ITEM: 6.9	REPORT SUMMARY MINOR VARIANCE APPLICATION FILE NUMBER A047/24
------------------	--

MINOR VARIANCE APPLICATION FILE NUMBER A047/24

CITY WARD #:	2
APPLICANT:	Marcello Quintieri
AGENT:	Jonathan Benczkowski
PROPERTY:	105 Kilmuir Gate, Woodbridge
ZONING DESIGNATION:	See below.
VAUGHAN OFFICIAL PLAN (2010) DESIGNATION:	Vaughan Official Plan 2010 ('VOP 2010'): "Low-Rise Residential".
RELATED DEVELOPMENT APPLICATIONS:	None
PURPOSE OF APPLICATION:	Relief from the Zoning By-law is being requested to permit a proposed cabana and reduced landscaping requirements in the rear yard.

PROP. CANOPY OVER EX. PATIO AND NEW UNHEATED CABANA AT ONE FAMILY DWELLING

1 SITE PLAN **Received**
March 28, 2024

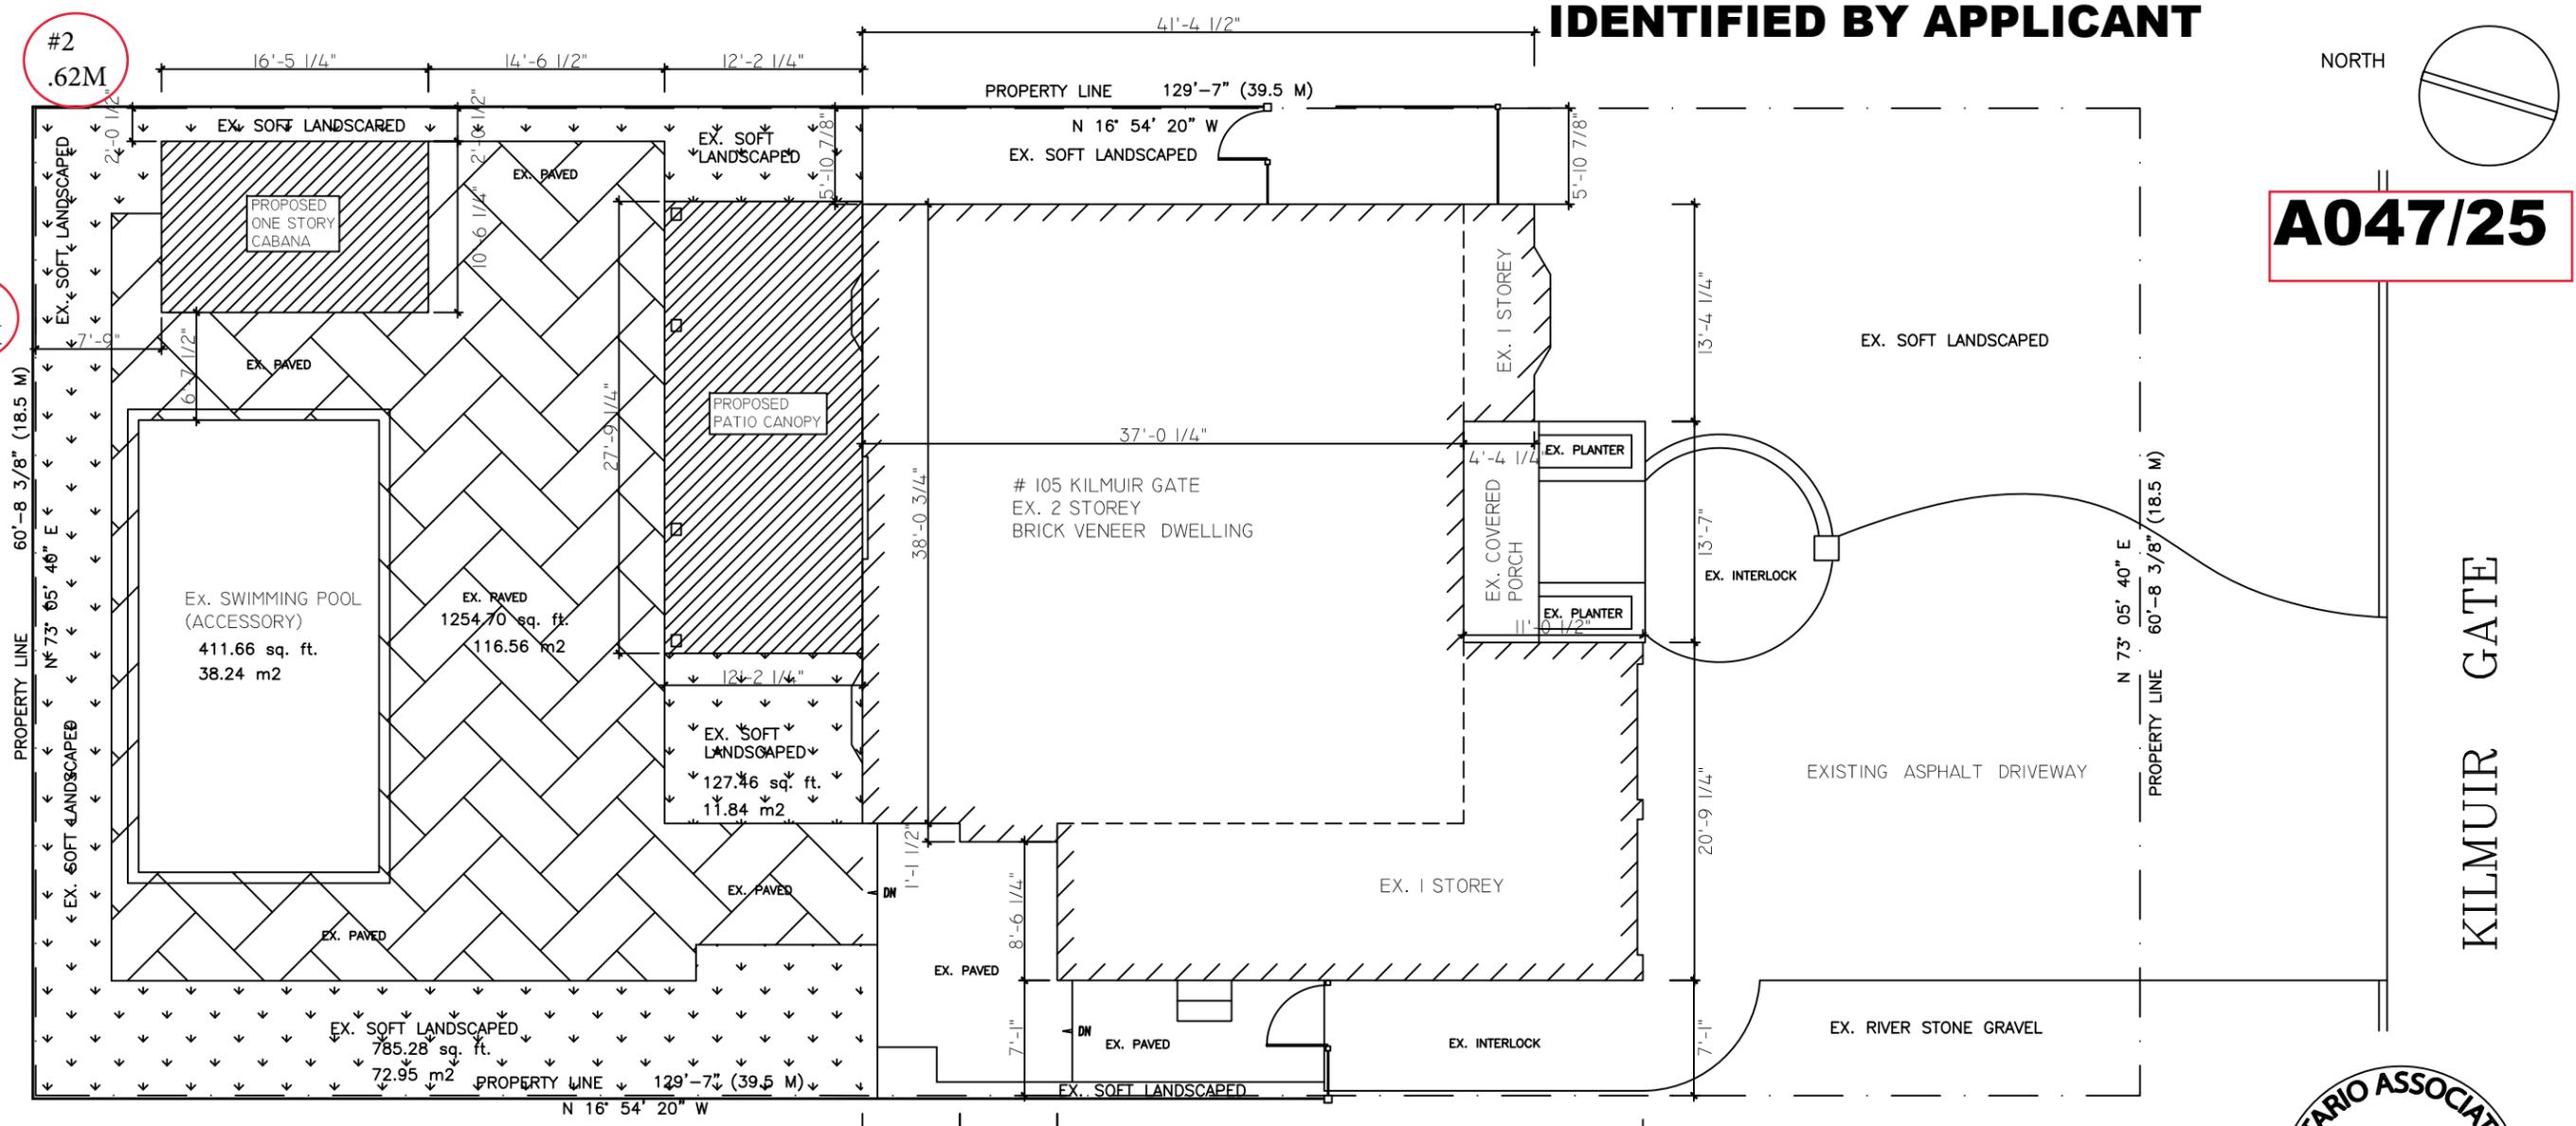
Development Planning Staff have no objection to Variances 1 through 3 to permit a reduced rear yard setback (Variance 1), as well as a reduced interior side yard setback measured to the Cabana wall (Variance 2) and Cabana eave/gutter projections (Variance 3). The Cabana is proposed in the north-east corner of the rear yard and is relatively modest in size with a flat roof to assist in addressing any potential concerns with massing on the neighbouring properties to the north (185 & 179 Wycliffe Avenue) and to the east (113 Kilmuir Gate). There is some existing vegetation (mature trees) at the rear of the Cabana on the subject property as well as on the property to the east. The proposed Cabana complies with the maximum height requirements and maximum lot coverage requirements of the Zoning By-law for accessory structures. Therefore, the proposed accessory structure is not anticipated to have adverse use (privacy) or massing impacts on the neighbouring properties to the north (185 & 179 Wycliffe Avenue) or the property to the east (113 Kilmuir Gate) and the 0.62 metre minimum side yard setback from the Cabana provides sufficient space for maintenance and access purposes.

Development Planning Staff have no objection to Variance 4 to permit a reduction in the required minimum soft landscaping in the rear yard. The proposed 4.26% reduction is modest from a visual perspective and there is a fair amount of soft landscaping around the entire majority of the rear yard's perimeter. Development Engineering Staff have also reviewed the application and do not have any concerns regarding drainage. As such, Development Planning Staff are of the opinion that the proposed reduction in rear yard soft landscaping is desirable and appropriate for the development of the land and does
